Access Compliance Report

Public Rights-of-Way

(Curb Ramps)

Intersection ID: 28386	Main Street: MARVIN_RD	Cross Street: SOUTHAMPTON_COMMONS_DR	Location: N
ADA ID: 71427859E166	Ramp Type: Perp	Initial Pass/Fail: Fail	Overall Compliance: No
Severity Score: 22.5			
Codes/Mitigation Info/Possible Solution		Field Measurements/Component Compliance

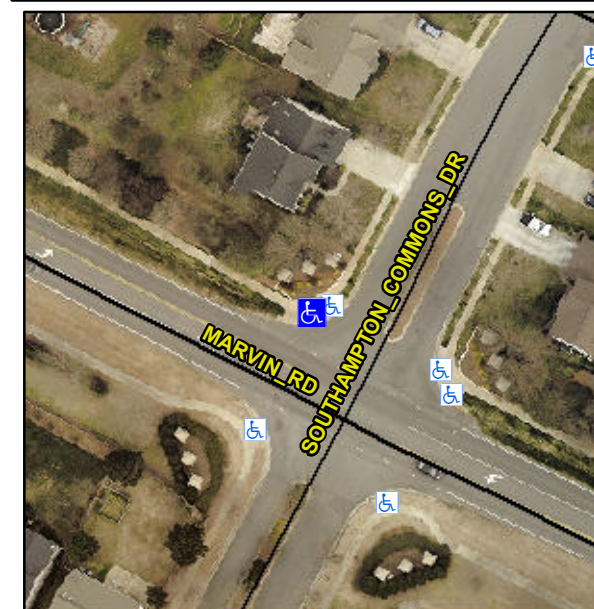
Not Found, R304.5.1, R304.2.2, R304.5.3

Compliance	Description	Data	Compliance	Description	Data
N/A	Ramp Length (in)	53.0	No	Ramp Slope (%)	9.9
No	Ramp Width (in)	36.0	No	Ramp XSlope (%)	3.0
N/A	Flare Type LT	N/A	N/A	Flare Type RT	N/A
N/A	Flare Slope LT (%)	N/A	N/A	Flare Slope RT (%)	N/A
N/A	Flare Traversable LT?	N/A	N/A	Flare Traversable RT?	N/A
N/A	Landing Length (in)	N/A	N/A	DWS Provided?	N/A
N/A	Landing Width (in)	N/A	N/A	DWS Contrast?	N/A
N/A	Landing Slope (%)	N/A	N/A	DWS Length (in)	N/A
N/A	Landing X Slope (%)	N/A	N/A	DWS Full Width?	N/A
N/A	Landing Curb? (Y/N)	N/A	N/A	DWS Offset (in)	N/A
N/A	Shared Landing?	N/A			
N/A	Gutter Ponding?	N/A	N/A	Gutter Slope (%)	N/A
N/A	Gutter Lip Ht (in)	N/A	N/A	Gutter X Slope (%)	N/A
N/A	Painted X Walk1?	No	N/A	Painted X Walk2?	N/A
	X Walk 1 Direction	To SW		X Walk 2 Direction	N/A
N/A	X Walk 1 Width (in)	N/A	N/A	X Walk 2 Width (in)	N/A
	X Walk 1 Slope (%)	0.4		X Walk 2 Slope (%)	N/A
	X Walk 1 X Slope (%)	0.5		X Walk 2 X Slope (%)	N/A

Remove & Replace Entire Ramp.
